SNIA Comments on ENERGY STAR® Data Center Storage V2.0 Draft 1

This document presents the comments of the SNIA Green Storage Technical Working Group and SNIA Green Storage Initiative on the ENERGY STAR Data Center Storage V2.0 Draft 1.

Response dated 12/06/2019

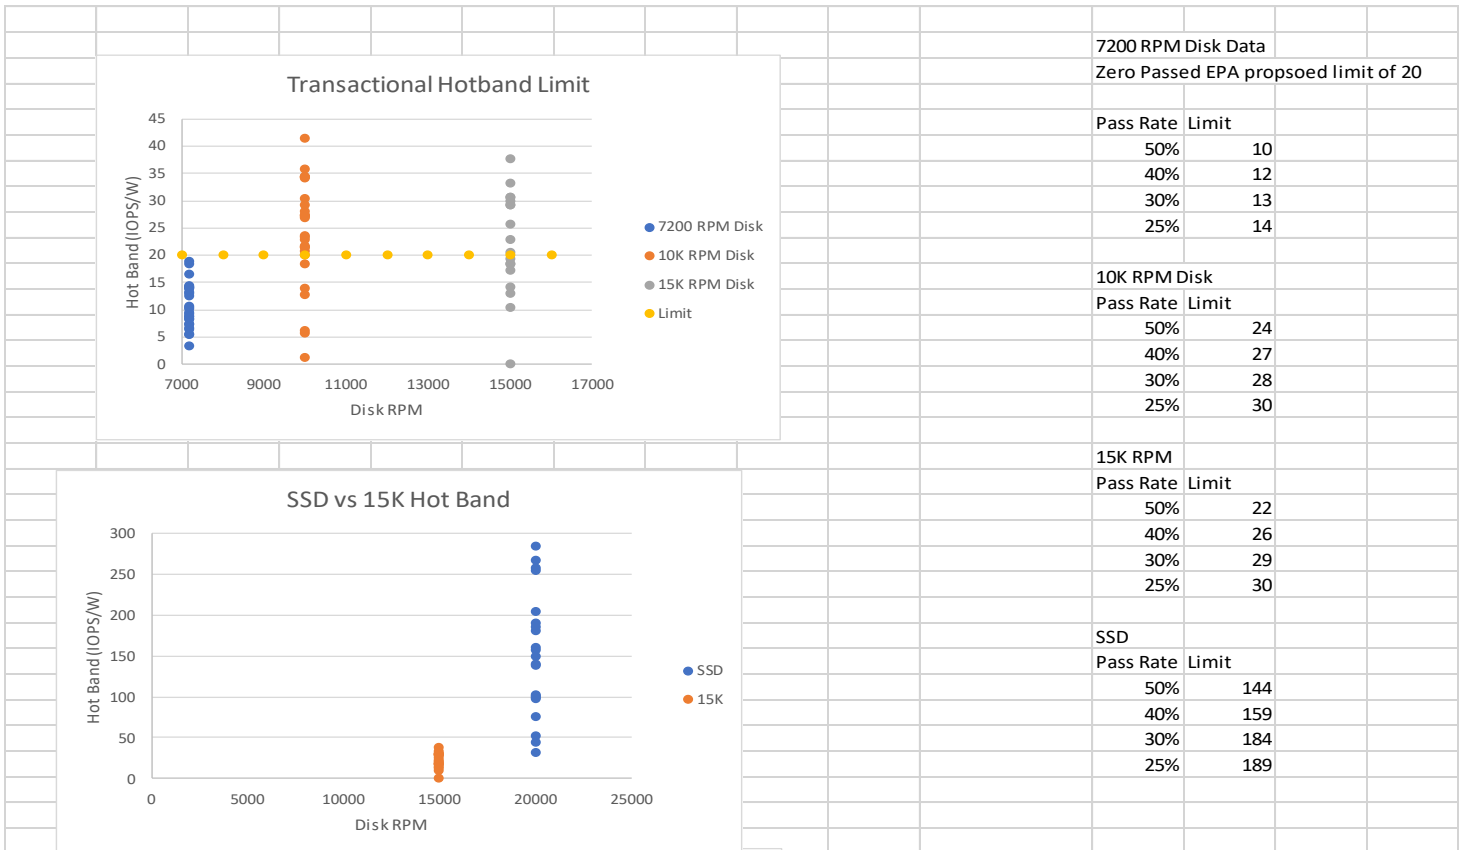
SNIA proposes breaking this up into Disk Set Online Category and NVSS Set Disk Access Category with a separate performance rating for each. As it is currently set up, it favors NVSS Set system over Disk Set. SNIA feels that a lower requirement for Disk Set and a higher requirement for NVSS Set would remove this bias. In addition, the Disk Set Online products are currently using 7200 RPM, 10,000 RPM and 15,000 RPM drives. The SSD costs for high performance storage have been coming down to the point where the 15,000 RPM drives are more costly than SSDs and the 10,000 RPM Drives are approaching parity with SSDs. It is anticipated that within the next couple of years, only 7200 RPM drives will remain in the Data Storage products. With the current limits, this will eliminate hard disk systems from Energy Star as only 10,000 RPM and 15,000 RPM drives can meet the proposed criteria. Alternately, this might drive Storage Product Manufacturers to use the higher speed drives for performance testing, but not actually sell any in systems, as 7200 RPM drives and SSDs will be more cost effective for customers. The Spreadsheet summary below shows the results of the SNIA analysis of the data combining Online 2, 3 and 4. This shows that with the current limit of 20 for all transactional systems the following result:

Disk Type	Quantity	Passed the EPA Limit	Percent
7200	27	0	0%
10K	27	21	78%
15K	18	10	55%
SSD	21	21	100%

Based on this, SNIA recommends setting separate limits for 7200 RPM disk drives, 10K & 15K RPM disk drives, and SSDs. The data indicates that the 10K and the 15K RPM drive systems provide similar results, so setting the same limit for both seems appropriate. The 7200 RPM drives are significantly different from the 10K and 15K RPM drives which indicates a lower level would be appropriate to avoid excluding them from consideration.

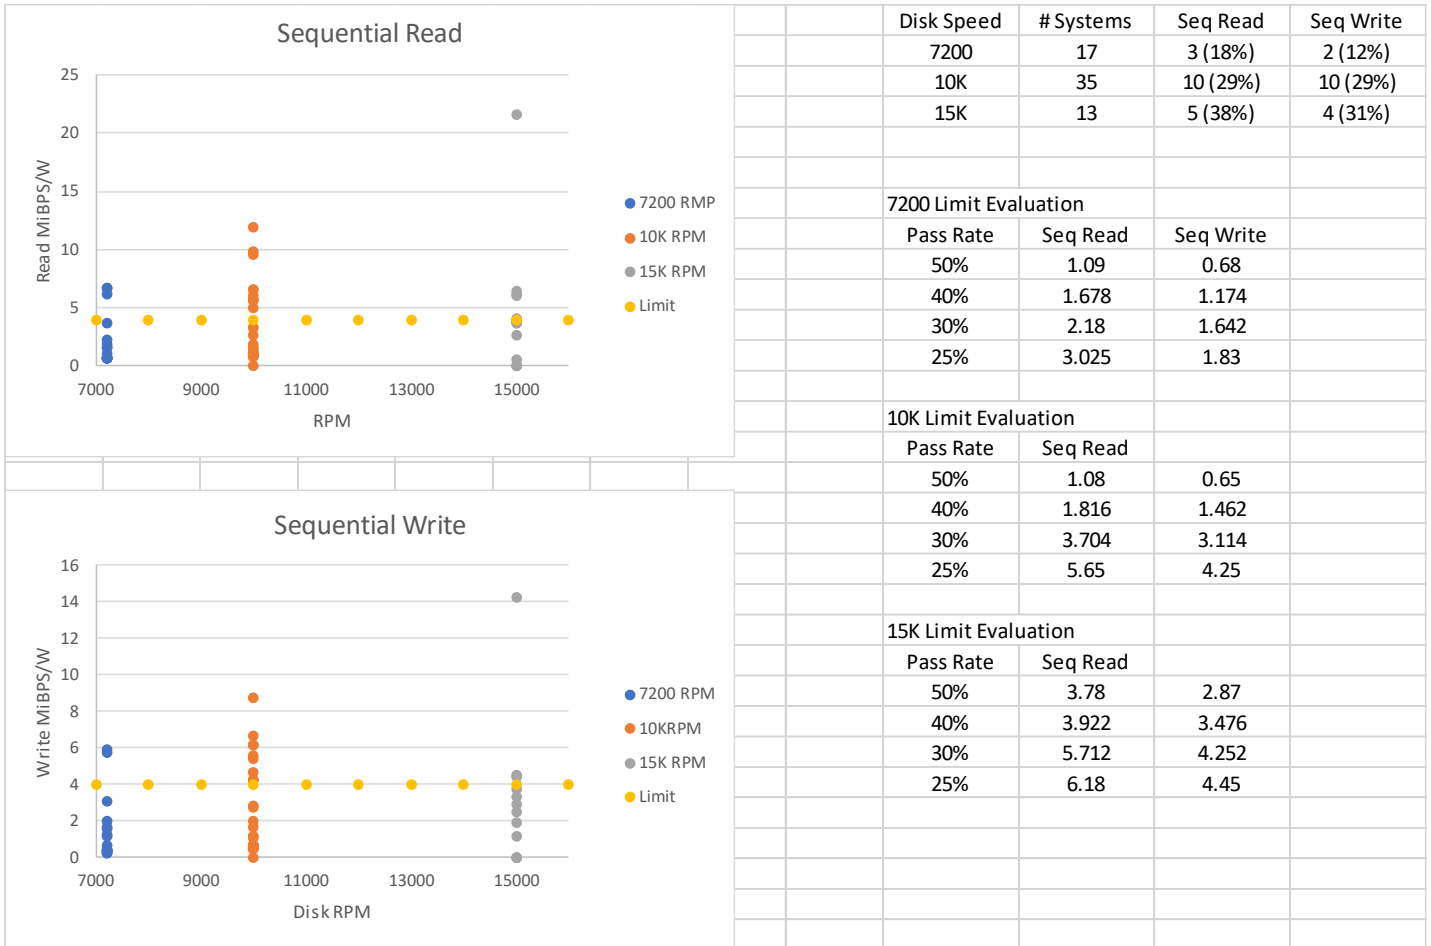
Like the discussion on the Transaction Hot Band, there is a distinction between 7200 RPM and 10K & 15K RPM drives. There is currently no data on SSDs, but one might surmise that they will be significantly faster than disk drives. The data below shows the results for the disk drives performance for the various speed disk drive systems. The proposed limit seems reasonable for the 10K & 15K drives but is again too high for the 7200 RPM drives. As is the case for the Transactional discussion, this could cause manufacturers to keep 10K RPM drives for the purpose of qualification, but most likely they would not be sold in actual systems during the life of this specification.

Based on this, SNIA recommends setting separate limits for 7200 RPM disk drives, and the 10K & 15K RPM disk drives. The data indicates that the 10K and the 15K RPM drive systems provide similar results, so setting the same limit for both seems appropriate. The 7200 RPM drives are significantly different from the 10K and 15K RPM drives which indicates a lower level would be appropriate to avoid excluding them from consideration.
